Re: Comments – Kern County Subbasin

**Kern County Subbasin Technical Working Group’s Comments
regarding the
Kern County Subbasin Probationary Hearing Draft Staff Report’s
preliminary review of the Subbasin’s 2024 Plan**

4.1.6 Preliminary Review of 2024 Draft Groundwater Sustainability Plans

Figure 1. Water level transect along cross section E-E' comparing Fall 2015, MO, and MT groundwater elevations.

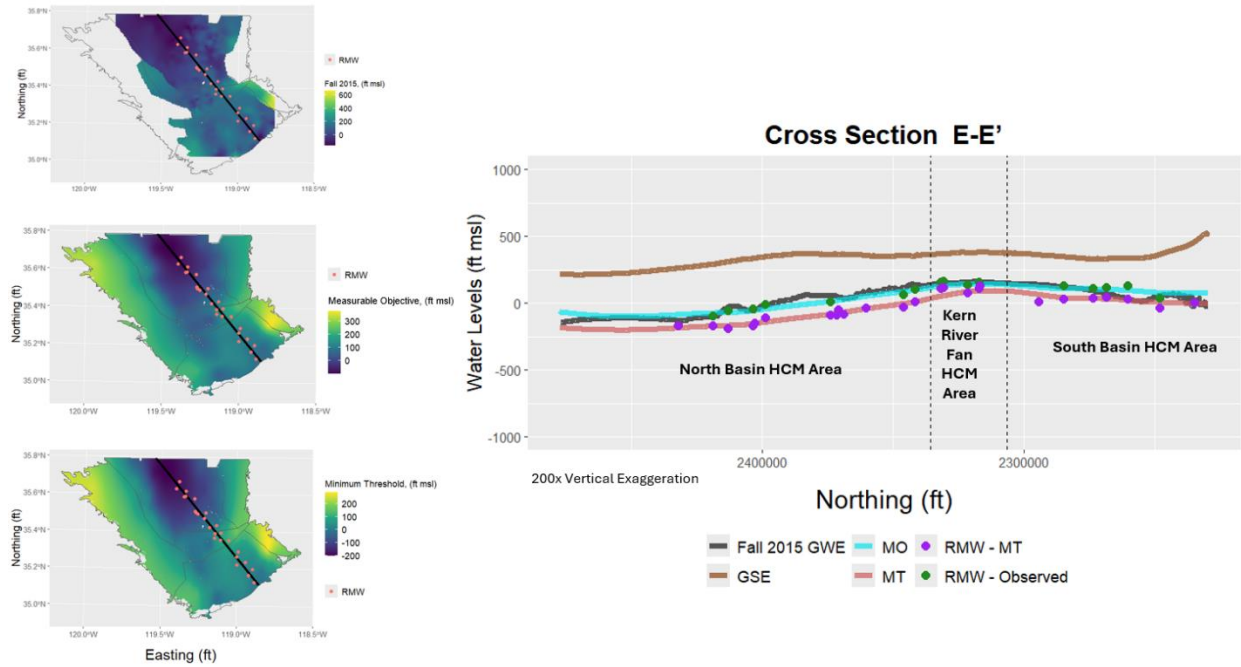
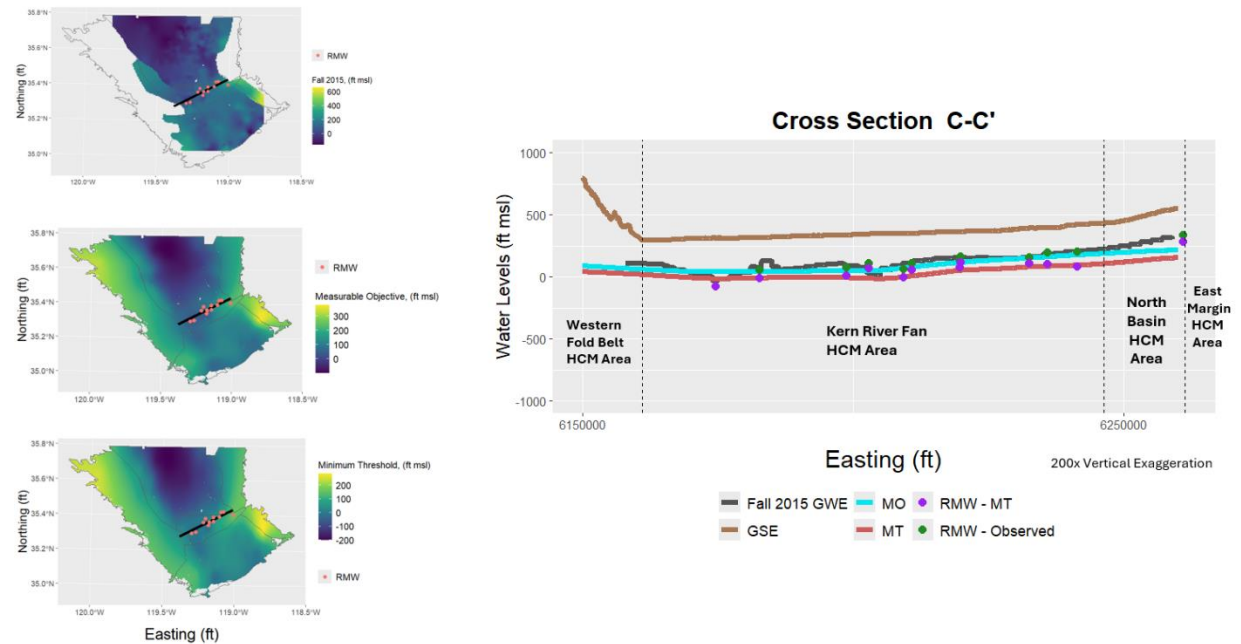
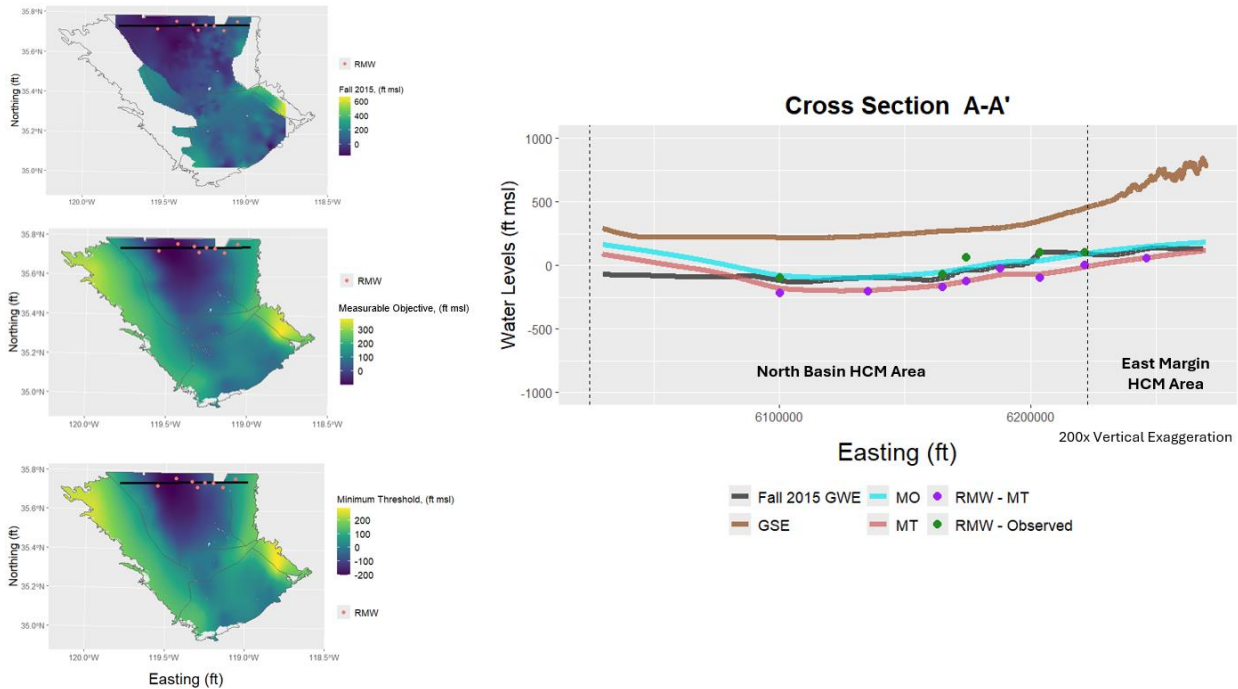
- *Board staff note that the use of regionally-averaged declining elevation trends leads to groundwater level MTs that vary dramatically across “hydrological areas” of the subbasin and may have resulted in a skewed (heavily weighted toward areas of more pumping and lower elevation) approach in setting MTs. This results in inconsistent management action triggers across plan areas, an issue previously identified by DWR across the 2022 GSP plan areas due to lack of coordination (Consistent with Coordination deficiency 1a).*

The SWRCB Draft Staff Report states that the “groundwater level MTs ... vary dramatically across ‘hydrological areas’ of the subbasin”. As shown in the contour maps and the three transects Figure 1, Figure 2, and Figure 3 below, the MT (and MO) values in fact do not “vary dramatically” between HCM Areas. They instead appropriately reflect the localized water level conditions across the Subbasin similar to those observed in Fall 2015. Similarly, spatial interpolations of the MTs and MOs at RMWs are similar to the Fall 2015 water level spatial interpolation. It should be noted

that the transects show smooth MT and MO interpolated values, and some of the apparent discrepancy at the RMW points is related to the translation across up to a two-mile distance to the transect lines.

FIGURE 3.2-7. Analysis of Past Operations: Time vs. Affected Area Outside the Kern Water Bank Exceeding ± 5 Feet Differences in Groundwater Elevations (“With Kern Water Bank Operations” Minus “Without Kern Water Bank Operations”), 1995-2014

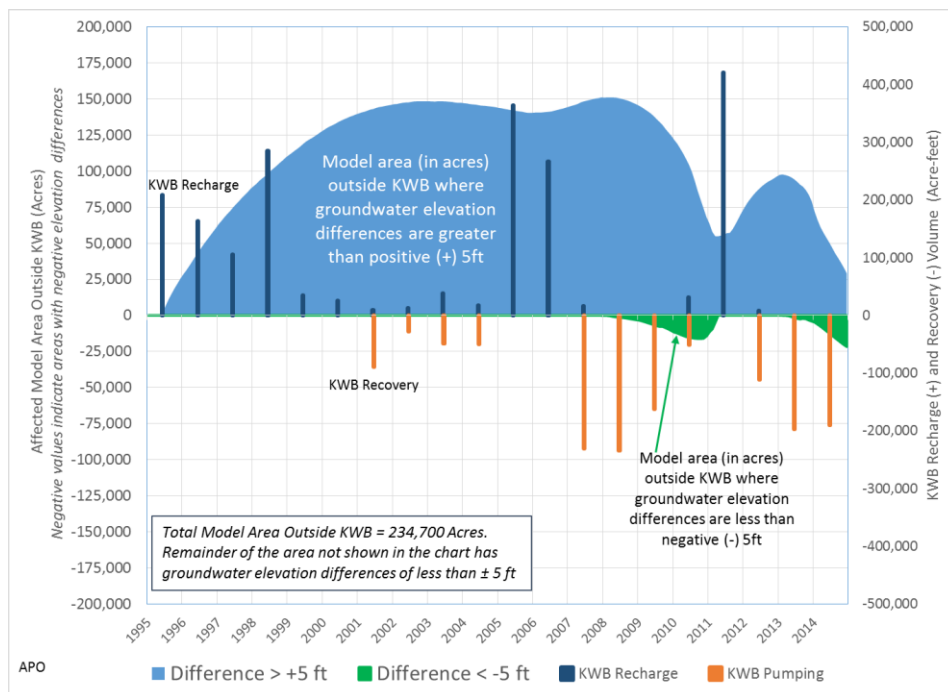
- *Plans lack clarity on banking operations and how they impact the ability of the basin to avoid hitting MTs. This is especially true given that the GSPs' Appendix E, Kern Fan Water Banking Program, stated that, "[t]he Projects cannot cause chronic lowering of groundwater levels or a reduction in storage" (2024 Draft Main GSP, Appendix E. p. 7) (Groundwater Level deficiency).*

DWR conducted an in-depth analysis of KWB operations in a 2016 Environmental Impacts Report (EIR) which included modeling the potential impacts of the KWB project for the 1995-2014 period. An analysis of with project operations and without project operations documented the effects of the project on adjoining areas. These effects are most simply summarized on Figure 3.2-7 which illustrates the area outside the KWB where changes in water levels exceeded 5 feet, either up or down, as a result of project operations. As shown, groundwater levels for significant areas outside the KWB were greater than 5 feet throughout the entire period under the with project operations scenario. Groundwater levels were lower than 5 feet for some areas for limited times toward the end of significant droughts.

Following the 1995-2014 period, there were three recovery periods and three significant recharge events. The volumes of water in these later recharge events exceeded those from previous recharge events, the recovery volumes were similar to or less than the 2012-2014 recovery period, and groundwater levels responded in a manner similar to those in the 1995-2014 period. Therefore, it would be expected that these later operations would raise groundwater levels in adjoining areas to the extent shown in Figure 3.2-7 through 2023. In addition, the operations of the other Kern Fan projects (Pioneer, Berrenda Mesa, and West Kern) are analogous to KWB operations, so it follows that the same chronic raising of groundwater levels has occurred as a result of these projects. Notably, at the end 2023, the volume of water in storage in the four projects approached 2 million acre-feet.

Figure 4. Cross section A-A' comparing showing distribution of clays along the Kern River Fan.

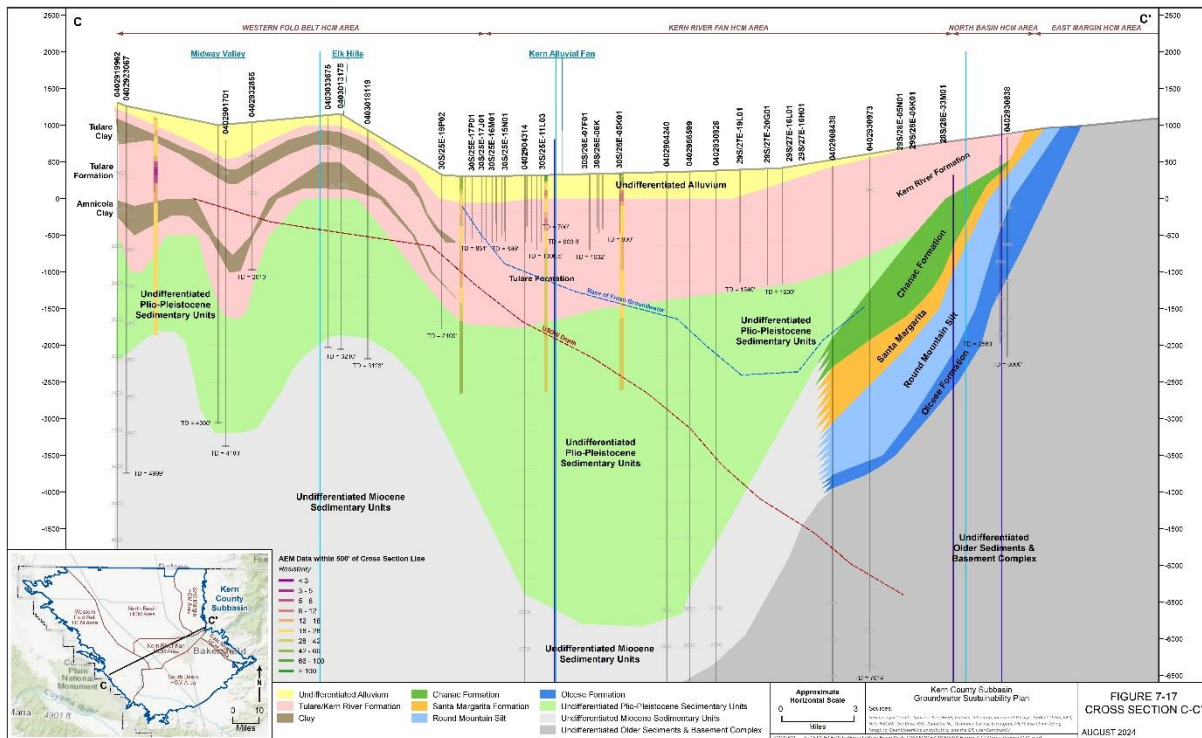
- The GSAs do not demonstrate a fundamental understanding of the Subbasin’s settings. For example, monitoring well networks for groundwater levels and groundwater quality do not differentiate between confined and unconfined aquifers separated by the E-clay (a confining layer), or other clay layers. Most monitoring wells appear to be screened in the confined aquifer, and therefore may not be protective of all beneficial users when water levels in the unconfined aquifer are lower than that in the confined aquifer. An understanding of groundwater levels and groundwater quality in the unconfined and confined aquifers, as well as subsidence and groundwater quality, is essential for characterizing hydrogeologic conditions throughout the subbasin. Well impact analyses, monitoring plans, or mitigation strategies developed without this knowledge are insufficient and may not be protective of beneficial*

For the 2024 Plan, the alluvium was defined as a single principal aquifer rather than subdividing it into upper and lower principal aquifers based on the actual mapping and analysis of the extent and thickness of the E-Clay. Figure 4 illustrates the lack of E-Clay along the Kern River Fan area. Utilizing maps of the E-Clay extent from the USGS and others (Croft 1972, Page 1983, 1986; PGA 1991), it was determined that the E-Clay is absent in over 60% of the Subbasin. In another 30%, the E-Clay is either discontinuous or near the margins, where zones above and below it are hydraulically connected (see Figure 7-24 of the 2024 Plan). Thus, given the limited and discontinuous nature of the E-clay, the aquifer system functions as a single principal aquifer with some local zonation influenced by the E-Clay and other clay layers (see Sections 7.2, 7.3 and 7.4), and was appropriately defined as such.

The variability of the E-Clay justifies establishing a single principal aquifer for the alluvial sediments. This is based on a fundamentally sound understanding of the Subbasin-wide hydrogeology. As an example of the hydraulic relationship along the northern fringe of the Subbasin, Figure 5 on the following page shows a series of hydrographs and land subsidence of nearby wells for four areas along Highway 99. The Delano Municipal Airport (Site A) is the furthest northern site within 2 miles of the boundary with the Tule Subbasin and shows examples of zonation among three aquifer zones at variable depth by location. The Highway 99 at Kimberlina Road (Site D) is the farthest southern location and only about 13 miles south of the Delano Airport. At the Delano Municipal Airport site, the groundwater elevations in the shallowest screened zone are higher than the lower zone at times but are nearly the same at other times. This relationship indicates the effects of local zonation as evidenced by increased subsidence at Site A compared to the other three sites that have similar groundwater elevations over the period of record. At the three more southern locations, the difference between the shallower and deeper screened intervals is minimal indicating little to no local zonation in these areas. The smaller magnitude of subsidence observed at the three southern sites compared to Site A is because the E-Clay and lesser clay layers diminish to the south (Figure 4). These wells provide an example of the observed hydraulic response observed in the Subbasin near the Friant-Kern Canal. While localized vertical head differences are present in some areas of the Subbasin, the alluvial aquifer at the Subbasin-scale is
